PROPOSED RESIDENTIAL DEVELOPMENT THE RESIDENCES AT 95 BREWSTER STREET PORTSMOUTH, NEW HAMPSHIRE PERMIT PLANS

RE: Request for Site Plan Approval at 49 Sudbury Street & 95 Brewster Street, Tax Map 138 / Lots 57 & 58

1) Prior to submission to Planning Board, plans shall be updated to address the following:

LANDSCAPE PLAN

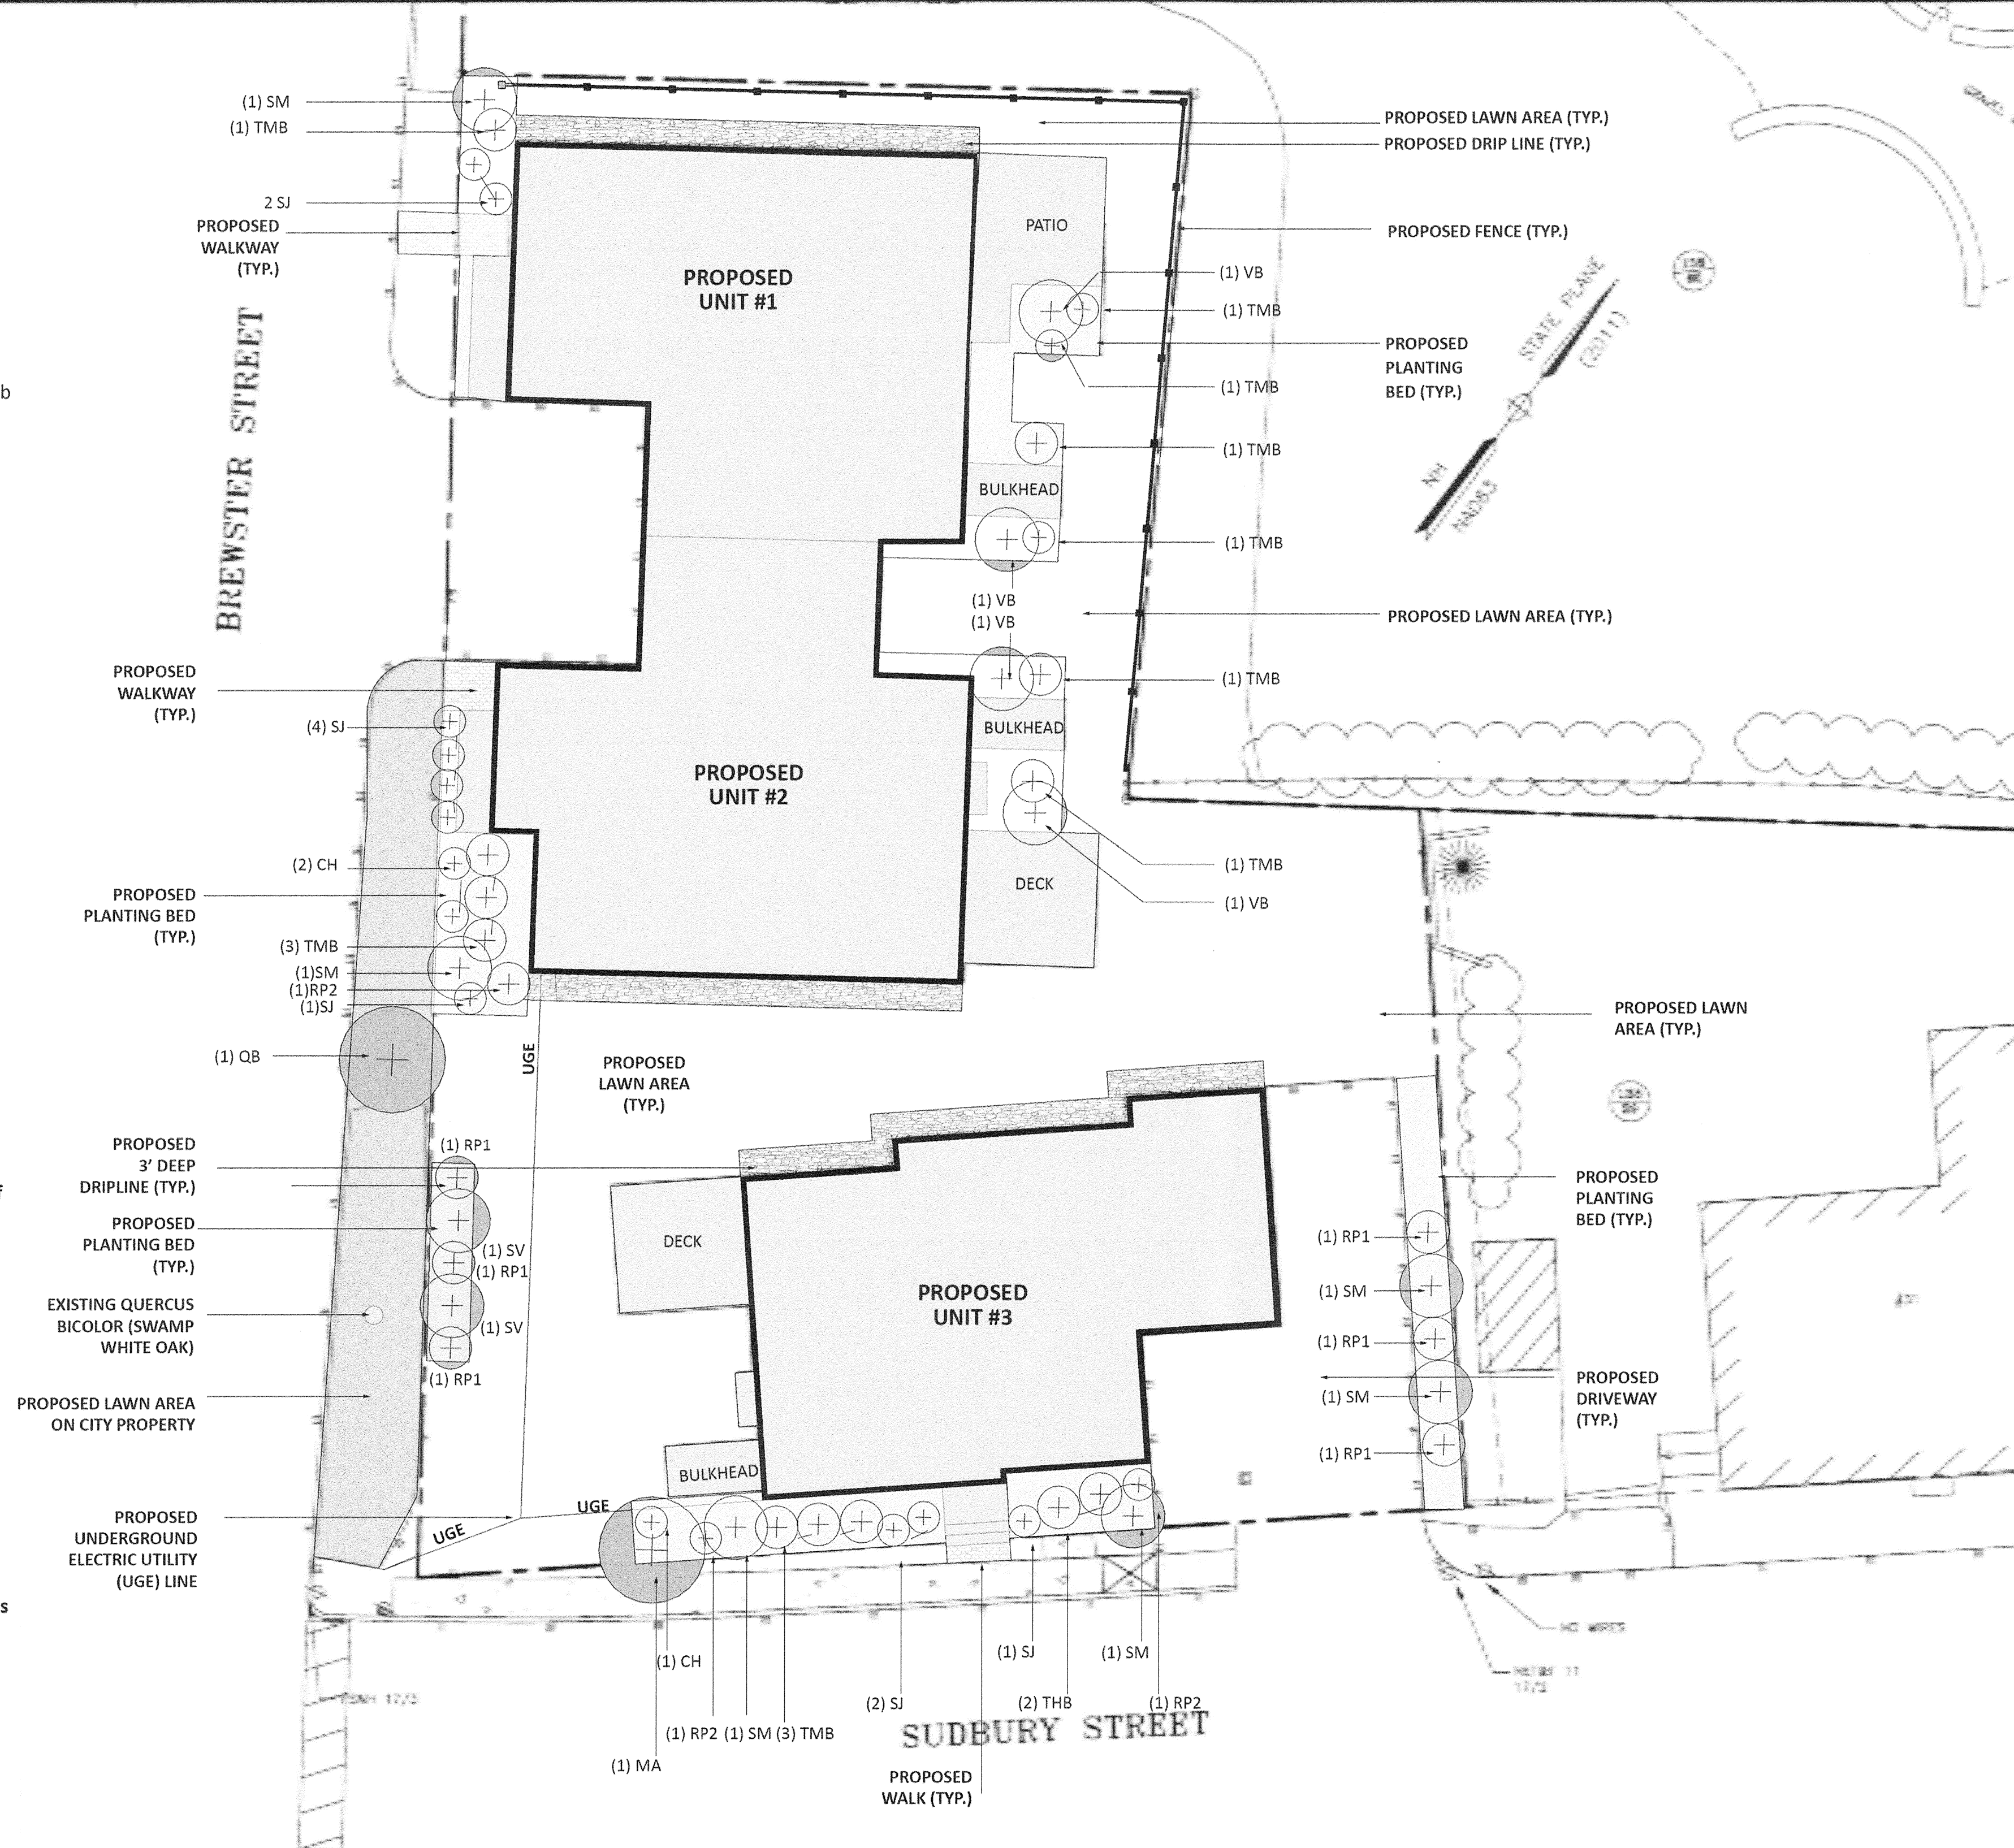
- n) The width of the driveway should be narrowed on the Sudbury Street house to 24 ft; **The driveway width has been narrowed - see Sheet C3.**
- o) The language found in the Landscaping notes should be consistent with the tree planting detail notes (e.g. planting note 4 calls for all burlap and cages to be pulled open in planting hole--not removed--, while tree planting detail calls for all cage and burlap to be removed); **The notes have been revised - see Sheet C6.**

- p) City trees along the property boundaries in in the ROW should be protected during demolition, excavation, and construction via the City's tree protection zone (TPZ) standards. Add a note to the Landscaping plan that replacement of trees is required, at cost to the developer, if they are damaged or destroyed during construction; **The Note has been added as Note 1 - see Sheet C6.**

- q) Add street trees along Brewster Street frontage subject to approval by the Trees and Greenery Committee. **A Note has been added as Note 2 - see Sheet C6.**

L TIP DOWN WITH WARNING STRIP
 C3 NTS

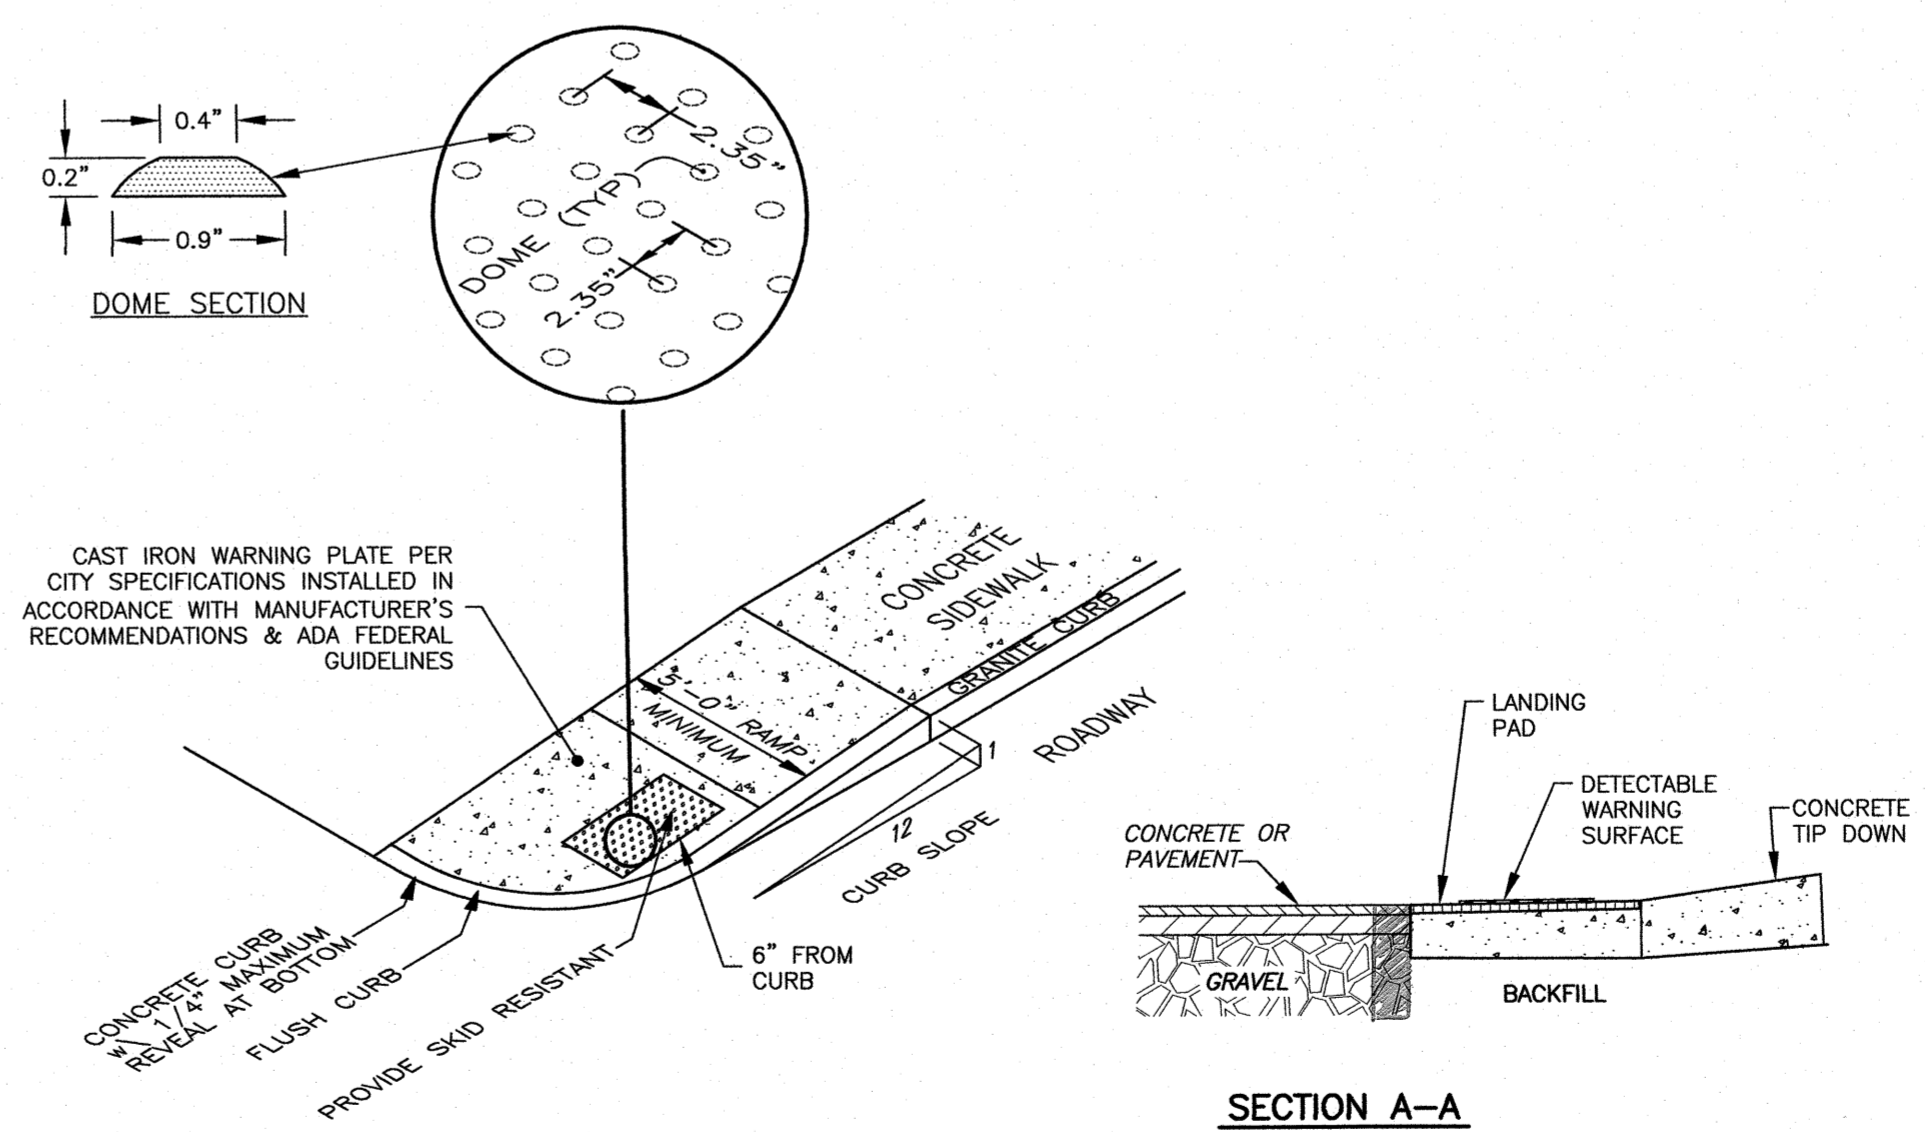
- b) An ADA accessible ramp shall be added to the sidewalk at the Brewster Street / Sudbury Street intersection; **The ramp / tactile warning strip has been added - see Sheet C3 and Detail L.**
